Technical BULLETIN

SAFETY RECALL

ALL 2015 FZ-07 MODELS

FACTORY MODIFICATION CAMPAIGN – Positive Battery Cable

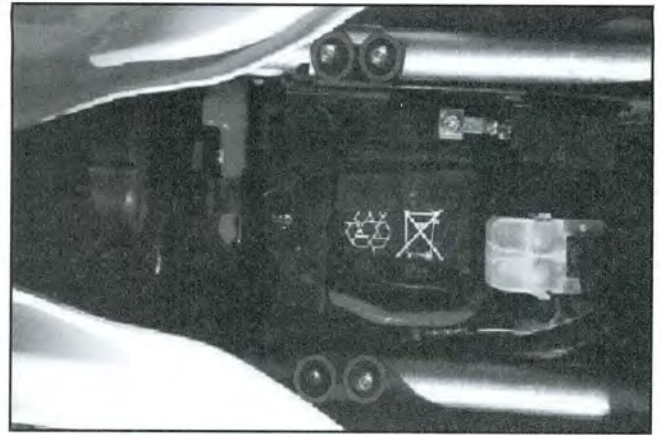
Yamaha Motor Corporation, U.S.A. has decided that a defect which relates to motor vehicle safety exists in all 2015 FZ07F and FZ07FC ("FZ-07") model motorcycles. In affected motorcycles, there is a possibility for the positive (red) battery cable to be pinched between the seat base and seat bracket due to inappropriate length of the battery cable and the shape of the seat bracket. If this happens, the positive battery cable's insulation may be chafed away over time, resulting in sparks, increasing the risk of fire.

To correct this problem, Yamaha is initiating a Factory Modification Campaign. Affected units must have the positive battery cable and seat bracket replaced with new ones of a different design and a revision sticker added to the Owner's Manual to show the new positive battery cable routing.

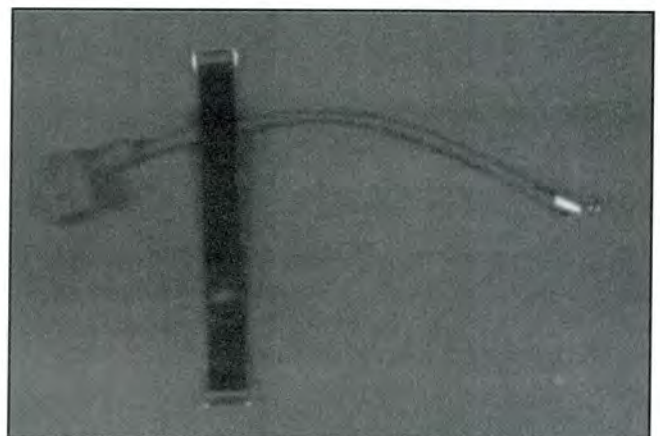
6. Install the new battery cable in the original battery retaining strap as shown.

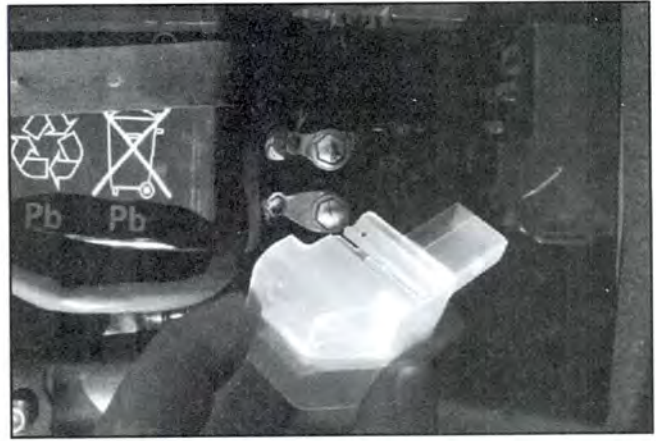
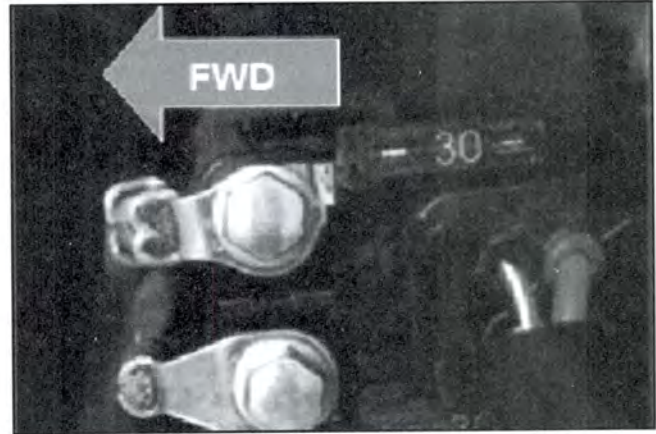
7. Connect the battery positive cable to the starter relay as shown.

The battery cable terminal must be oriented as shown.

Tightening Torque: 2.2 Nm (0.22 m-kgf, 1.6 ft-lbf, 19.5 in-lbf)

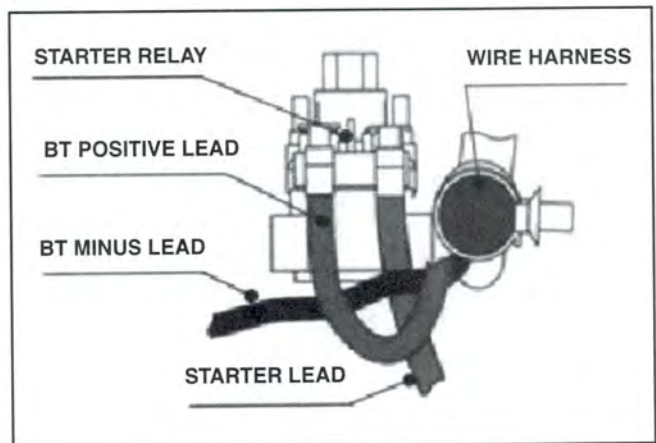
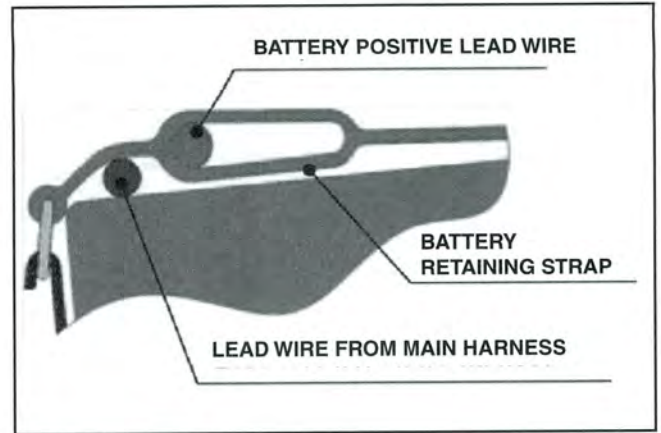
8. Route the wiring as shown in the adjacent figure.

9. Route the battery positive cable as shown in the adjacent figure. Reinstall the starter relay cover removed in step 4.

10. Connect the positive battery cable to the positive terminal of the battery and then the negative cable to the negative terminal. Reinstall the battery retaining strap.

Tightening Torque: 2.2 Nm (0.22 m-kgf, 1.6 ft-lbf, 19.5 in-lbf)

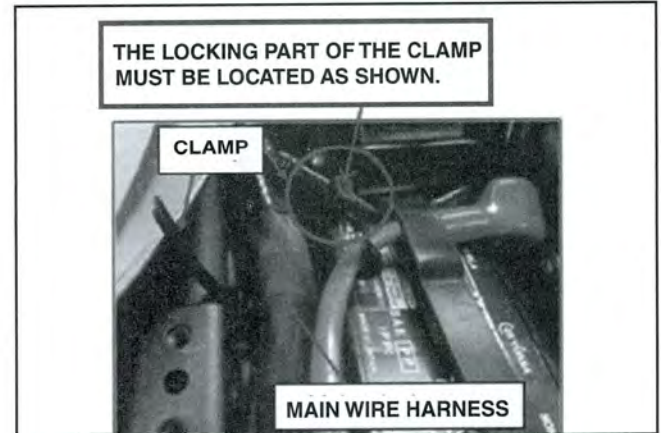
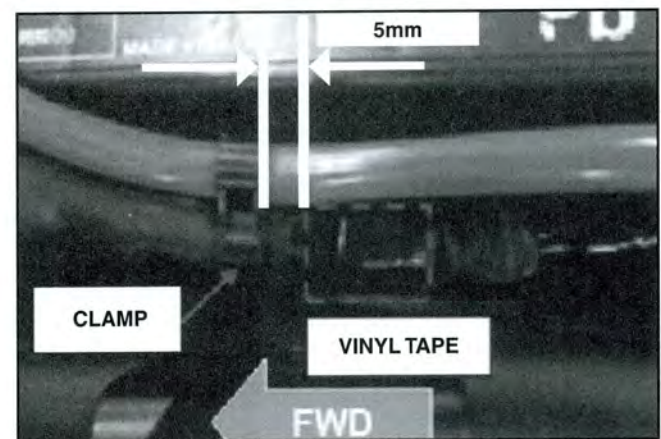
11. Install the clamp (cable tie) under the battery positive cable and the main wire harness.

12. Fasten the battery positive cable and the main wiring harness with the clamp 5mm forward of the vinyl tape on the main wiring harness.

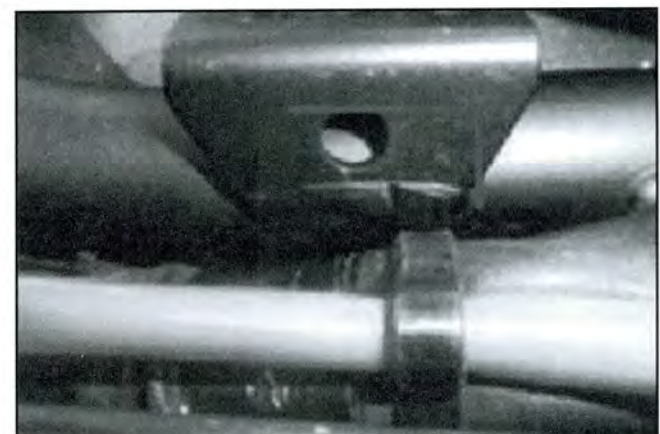
13. Trim excess clamp (cable tie). The cutting position must be below the red line in the adjacent photo.

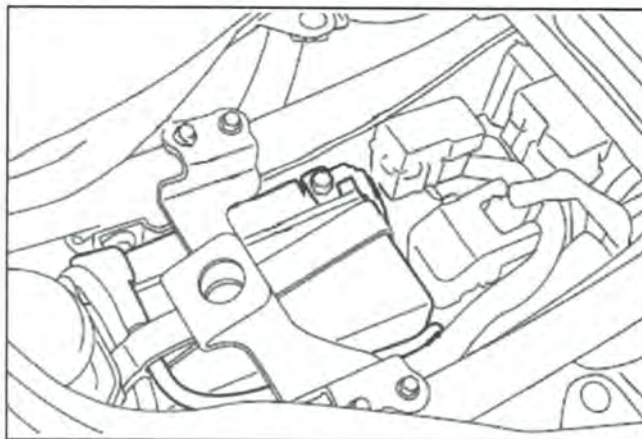
16. Affix the revision sticker on page 7-30 of the Owner's Manual (LIT-11626-28-07) as shown.

AFFIX THE STICKER ON THE BATTERY WIRE ROUTING FIGURE

IDENTIFICATION PROCEDURE

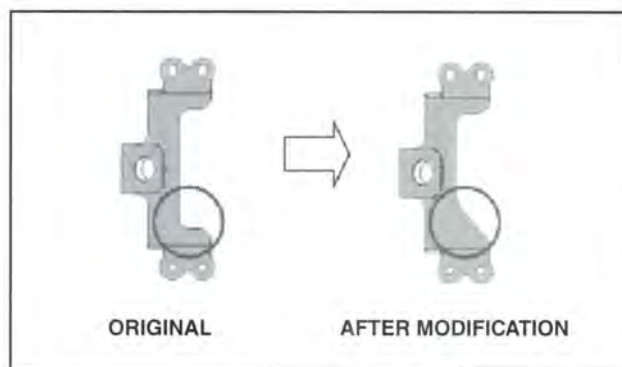
After modifying a unit, make sure to properly record and submit the warranty claim for this safety recall to update the unit's repair history in the Yamaha database. If you encounter an unfamiliar unit, check the Unit Status in YDS. A modified unit can also be identified by the shape of the seat bracket as shown below.
